Thursday, April 23, 2024
Addendum #3

Phillips Hawkins Residence Hall – HVAC Renovation Phase 1
UNC Greensboro
SCO # 22-24777-01A

PH-M260

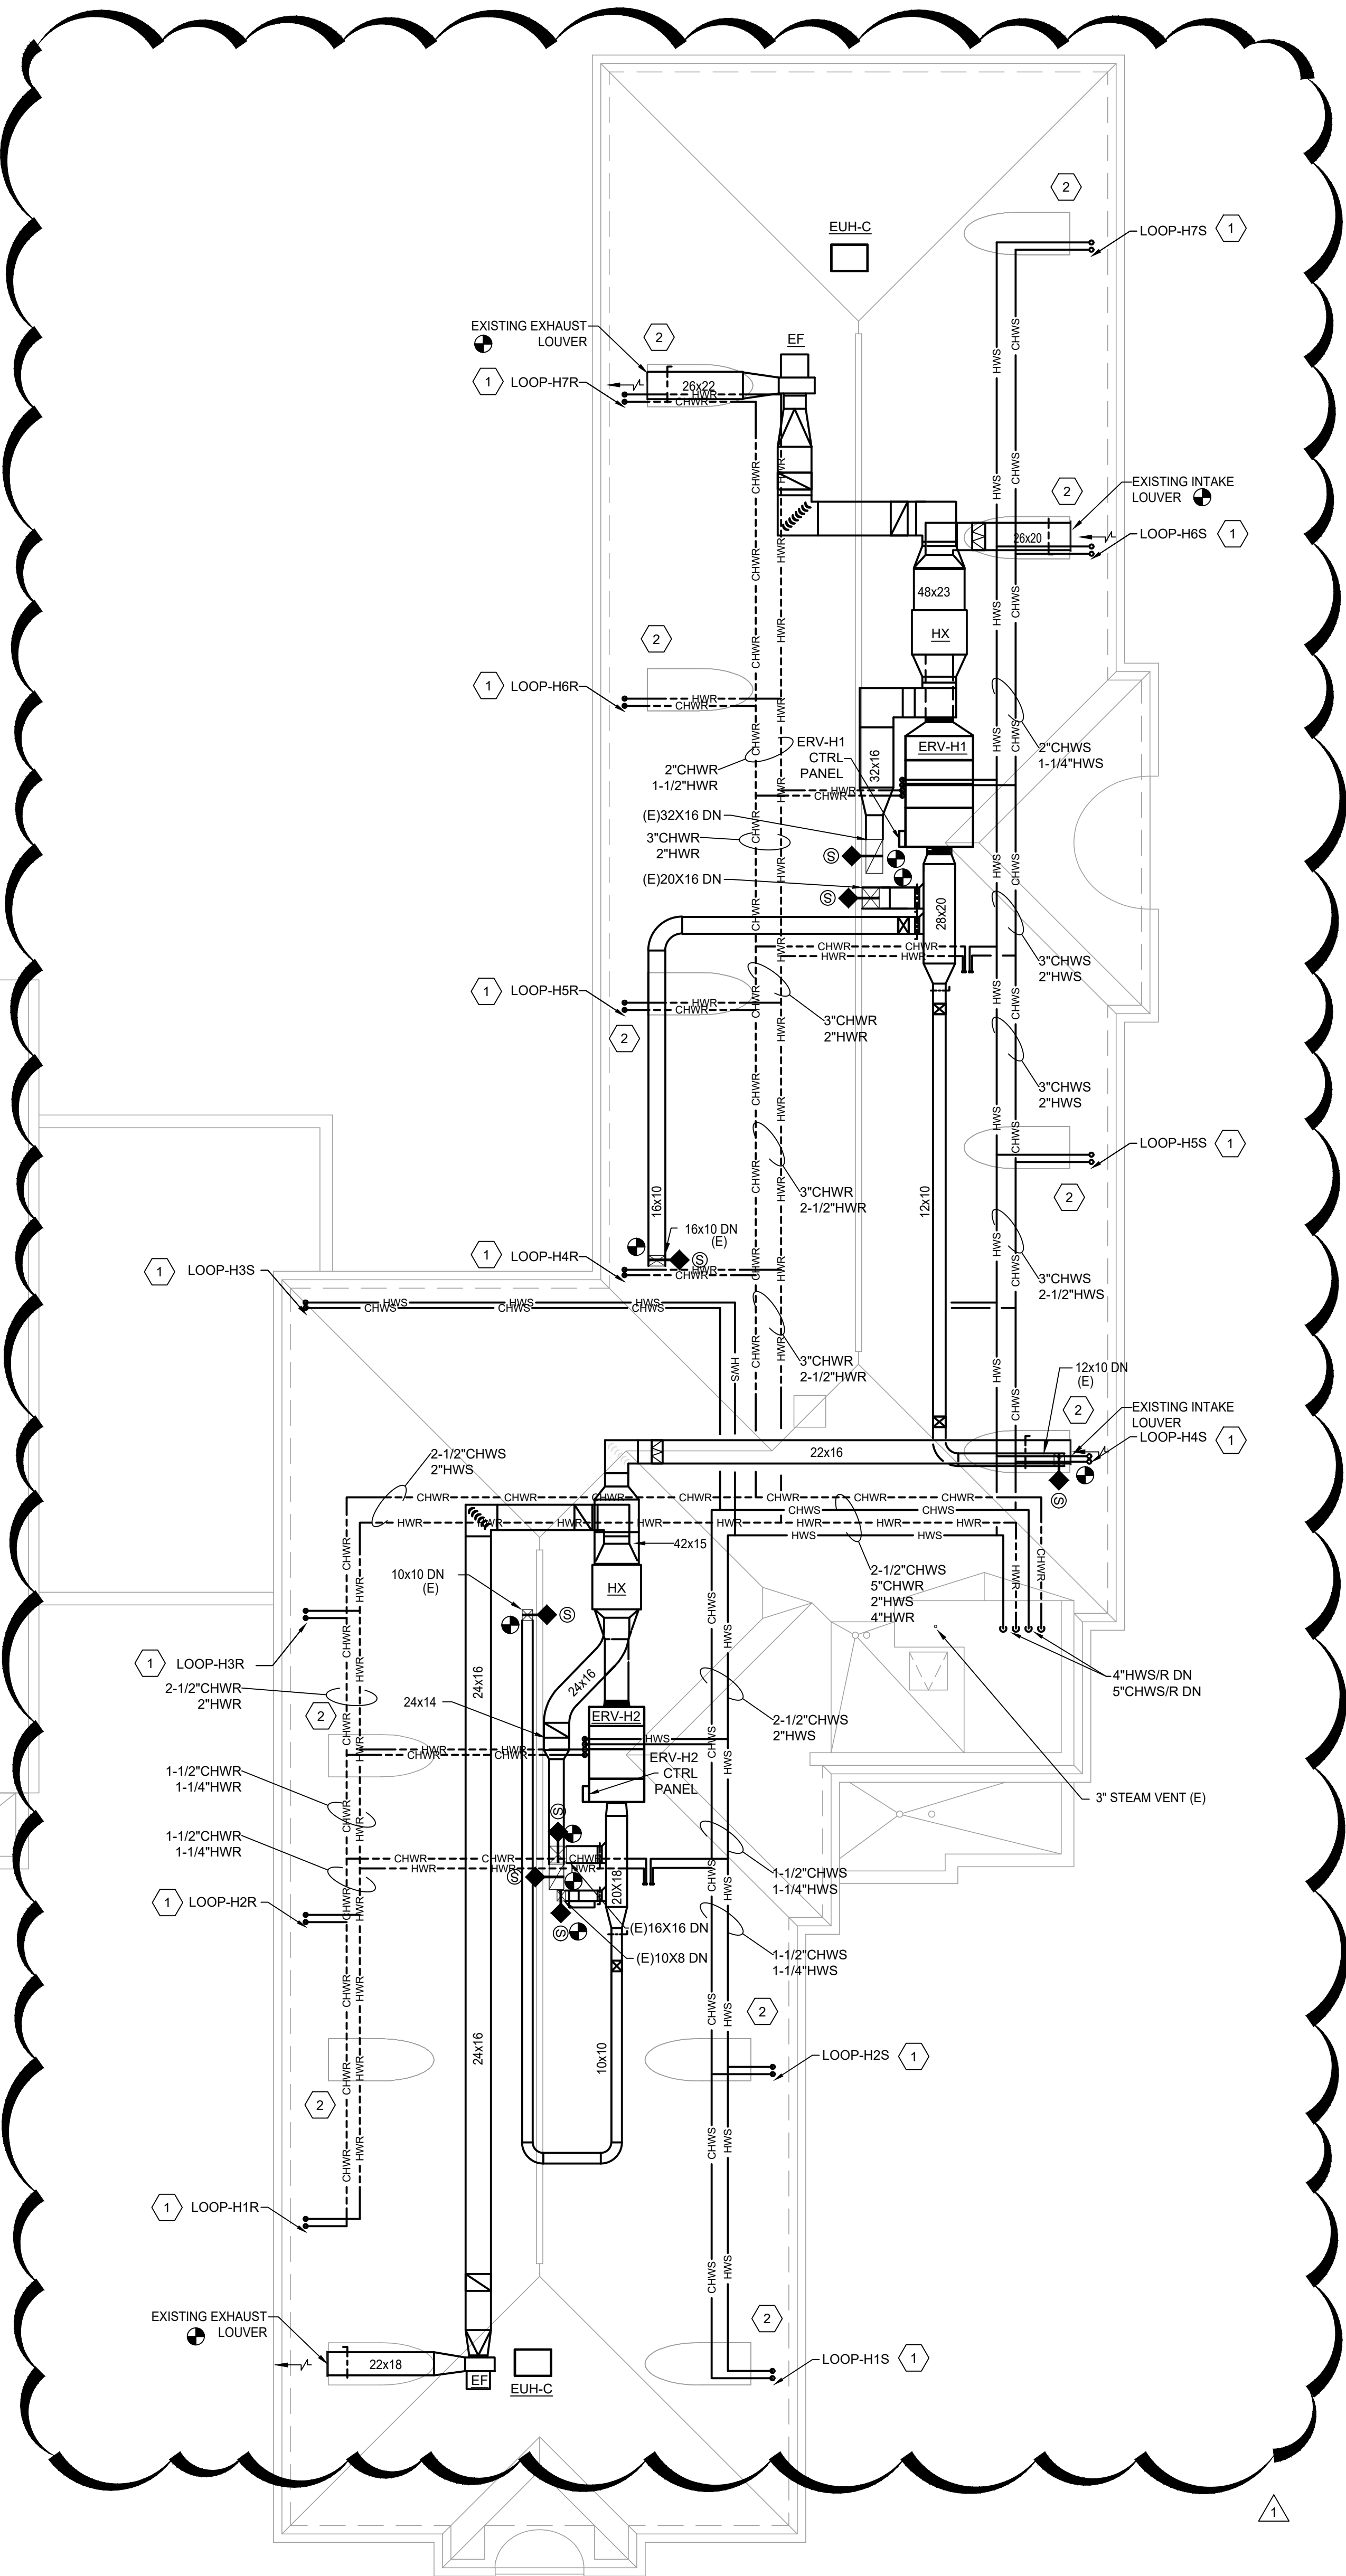
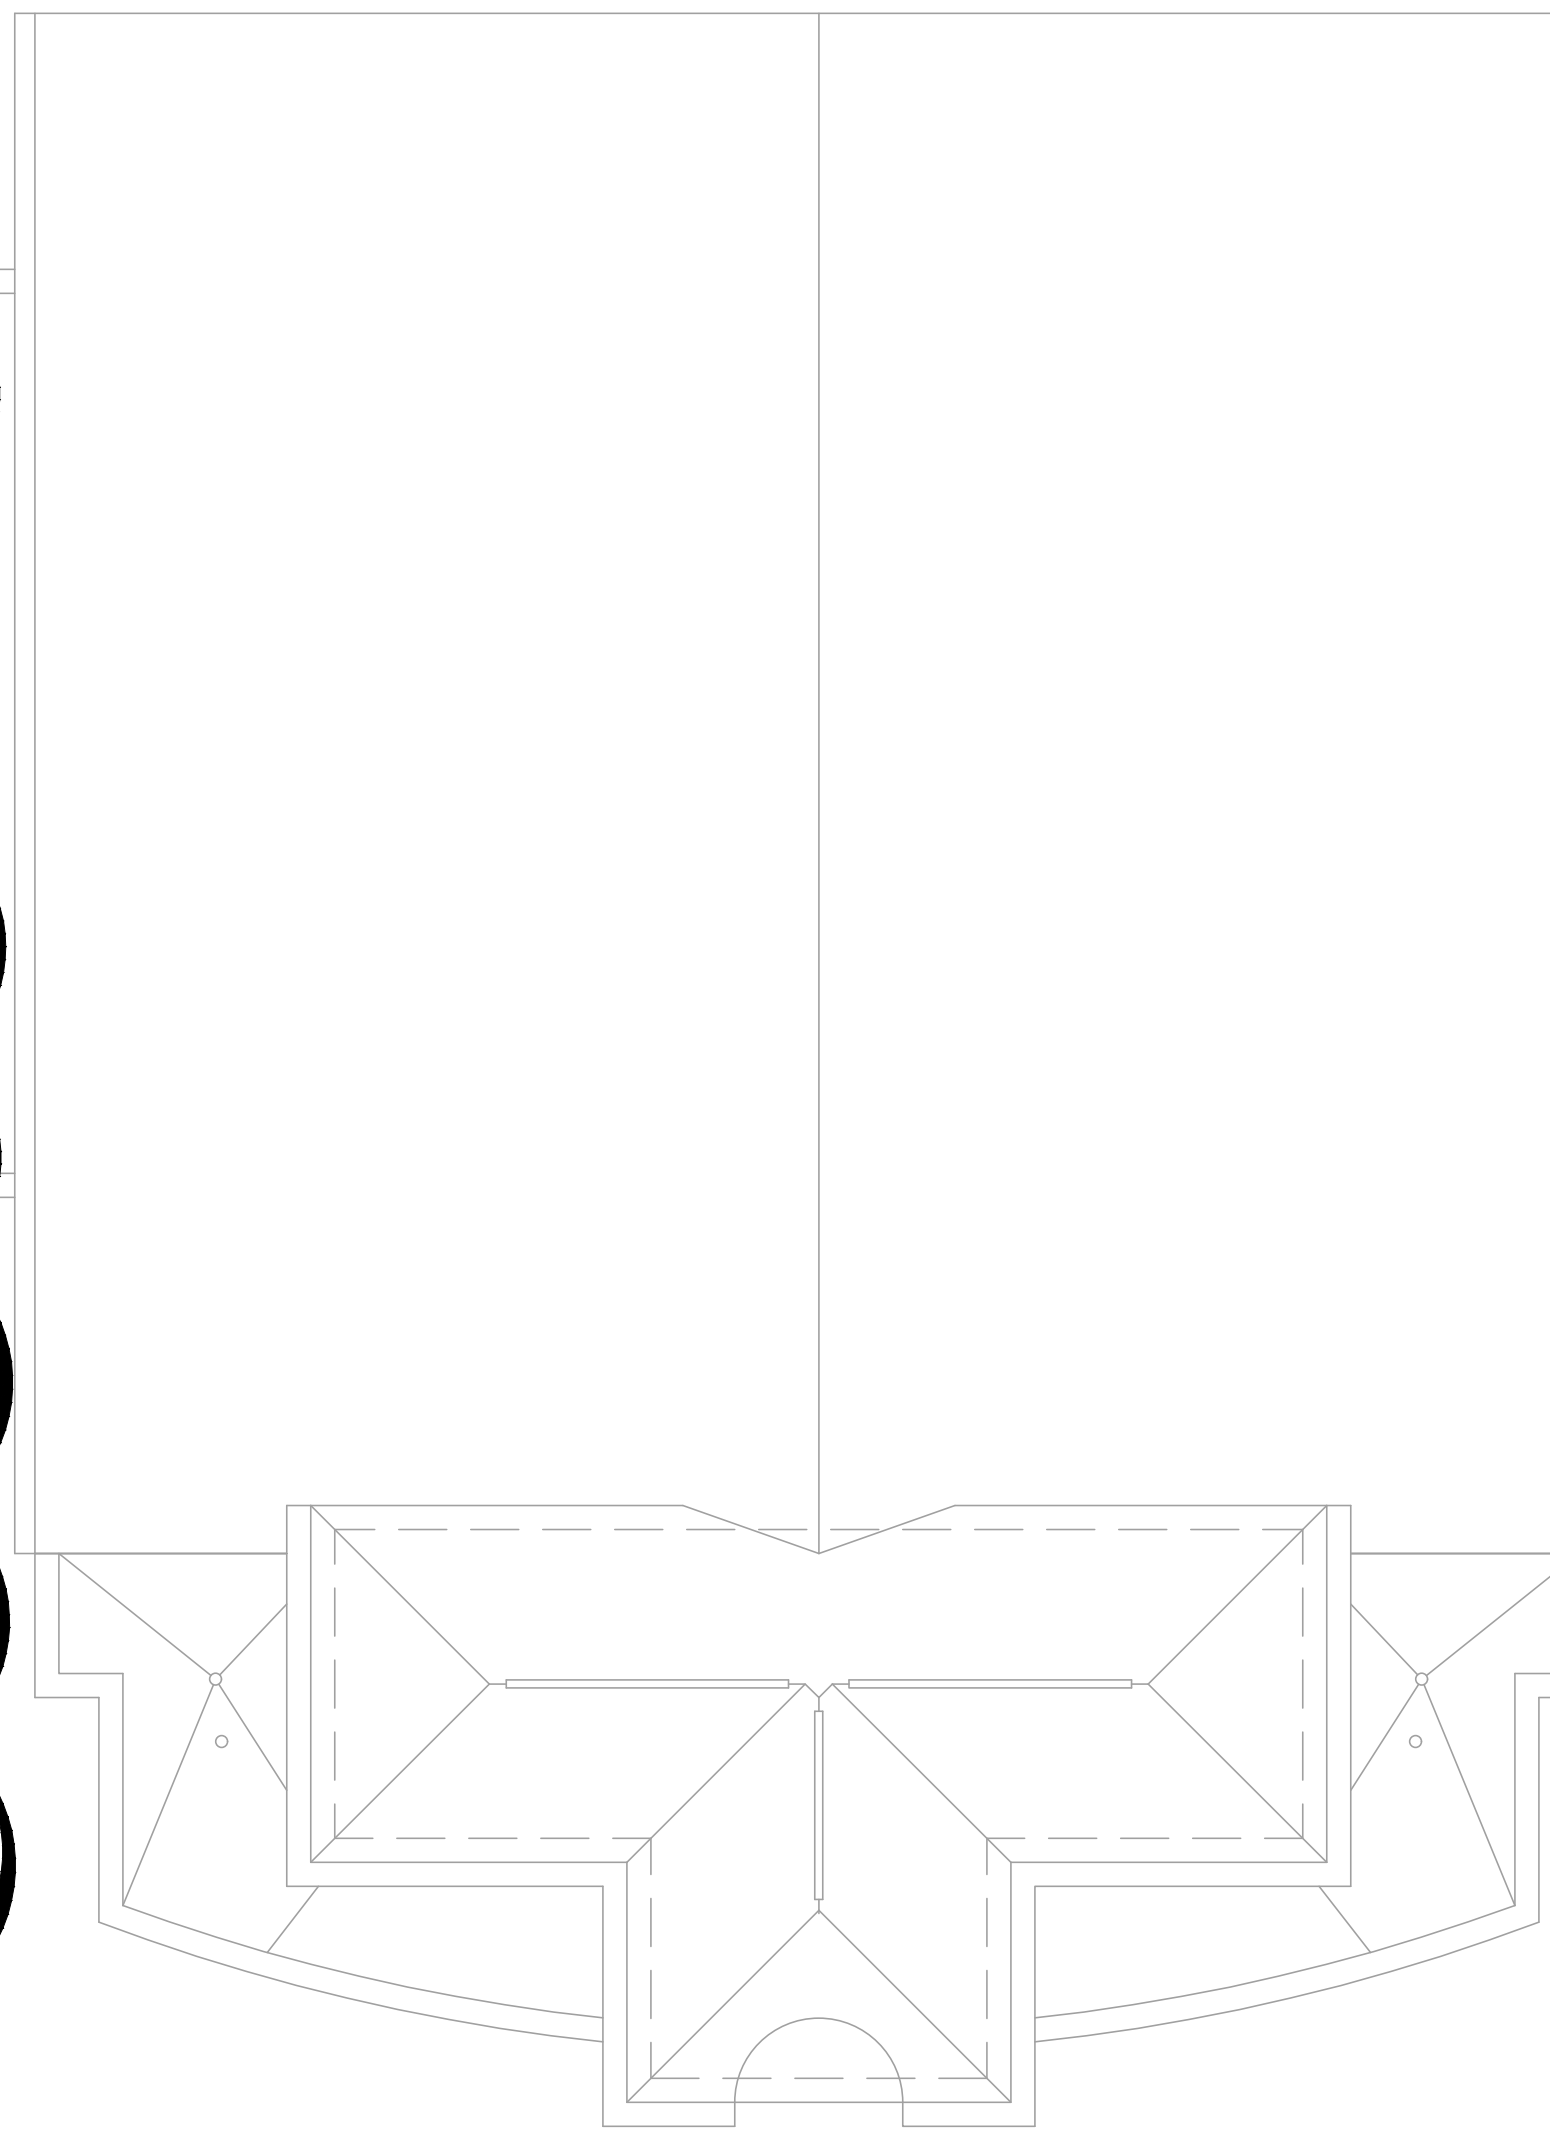
e) Q: PH-M260 does not show duct sizes for new work except for where the new duct connects to existing duct. Please provide duct sizes for new duct.

h) Q: The demo drawings show sizes on the duct that needs to be removed in the attic. The new drawings do not show duct sizes. Is it the intent to put the same size duct in the attic as shown on the demo drawings?

A: Please reference the attached revised PH-M260 for duct sizes.

A: Please reference the attached revised PH-M260 for duct sizes.
